Addendum 93: Regulation No. 94

Revision 1 – Amendment 1

02 series of amendments to the Regulation - Date of entry into force: 23 June 2011

Uniform provisions concerning the approval of vehicles with regard to the protection of the occupants in the event of a frontal collision

Figure 1
Measurement of V_b , V_1 , V_2

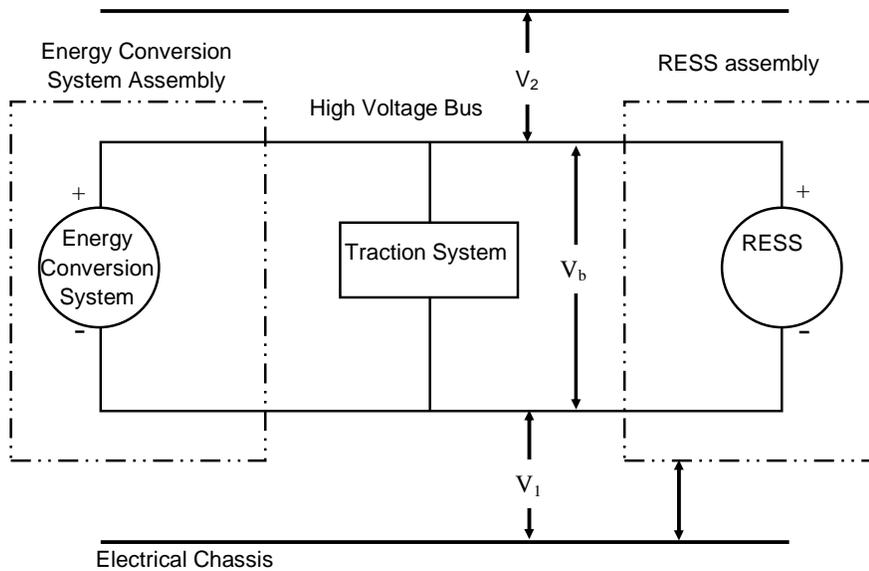
After the impact test, determine the high voltage bus voltages (V_b , V_1 , V_2) (see figure 1).

The voltage measurement shall be made not earlier than 5 seconds, but, not later than 60 seconds after the impact.

This procedure is not applicable if the test is performed under the condition where the electric power train is not energized.

Figure 2
 E.g. measurement of high voltage bus energy stored in X-capacitors

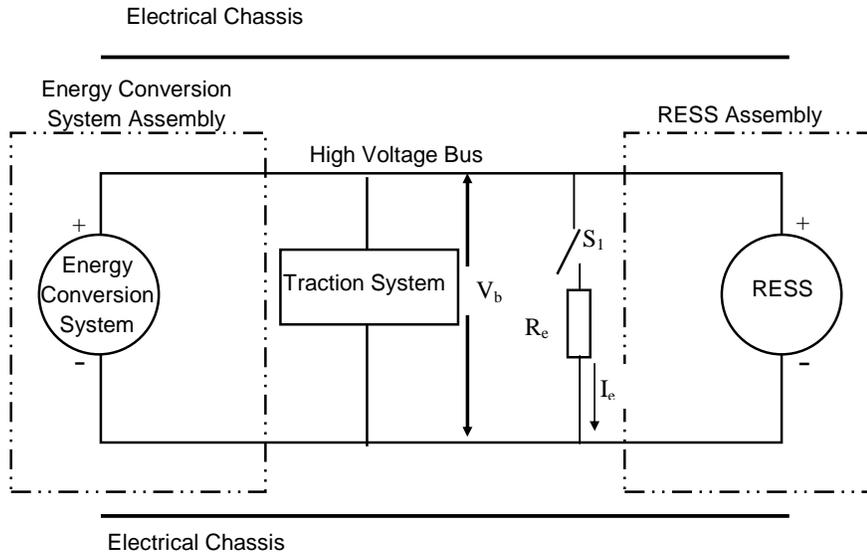
Prior to the impact a switch S_1 and a known discharge resistor R_e is connected in parallel to the relevant capacitance (ref. figure 2).

Not earlier than 5 seconds and not later than 60 seconds after the impact the switch S_1 shall be closed while the voltage V_b and the current I_e are measured and recorded. The product of the voltage V_b and the current I_e shall be integrated over the period of time, starting from the moment when the switch S_1 is closed (t_c) until the voltage V_b falls below the high voltage threshold of 60 V DC (t_h). The resulting integration equals the total energy (TE) in joules.

$$(a) \quad TE = \int_{t_c}^{t_h} V_b \times I_e dt$$

Figure 3
Measurement of V_1'

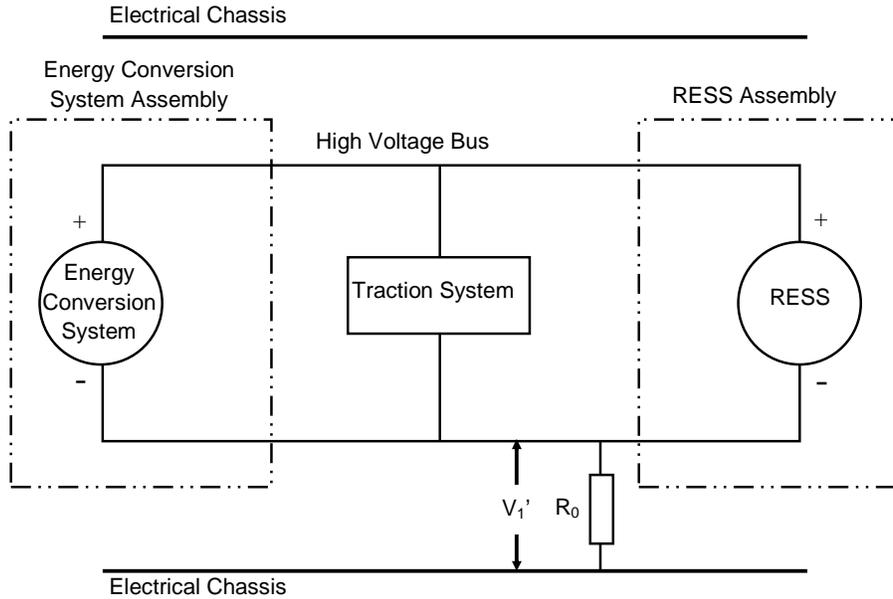
If V_1 is greater than or equal to V_2 , insert a standard known resistance (R_o) between the negative side of the high voltage bus and the electrical chassis. With R_o installed, measure the voltage (V_1') between the negative side of the high voltage bus and the vehicle electrical chassis (see figure 3). Calculate the isolation resistance (R_i) according to the formula shown below.

$$R_i = R_o * (V_b / V_1' - V_b / V_1) \quad \text{or} \quad R_i = R_o * V_b * (1 / V_1' - 1 / V_1)$$

Figure 4
Measurement of V_2'

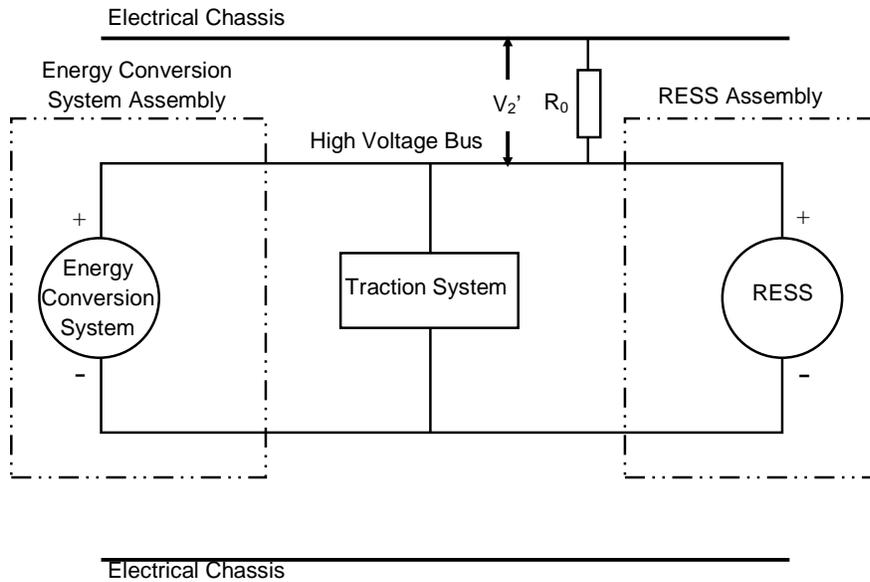
If V_2 is greater than V_1 , insert a standard known resistance (R_0) between the positive side of the high voltage bus and the electrical chassis. With R_0 installed, measure the voltage (V_2') between the positive side of the high voltage bus and the electrical chassis (see figure 4).

$$R_i = R_0 * (V_b / V_2' - V_b / V_2) \quad \text{or} \quad R_i = R_0 * V_b * (1 / V_2' - 1 / V_2)$$
